Product Change Notification

Change Notification #: 113161 - 00
Change Title: Intel® Server System R1304BTLSFANR, R1304BTLSHBNR, and R1304BTSSFANR PCN 113161-00, Product Material Chassis Modified to support AXXPRAIL
Date of Publication: July 28, 2014

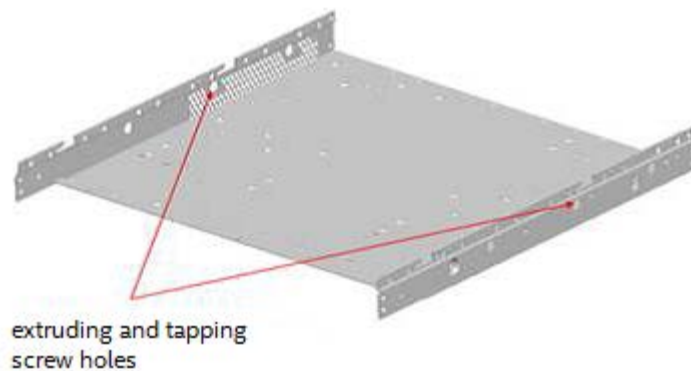
1. Remove two rail mounting studs to support the AXXPRAIL rail mounting brackets and add extruding and tapping screw holes (#6-32) to allow customers to add screw-in type rail mounting studs as needed.

See the following figure for change details.
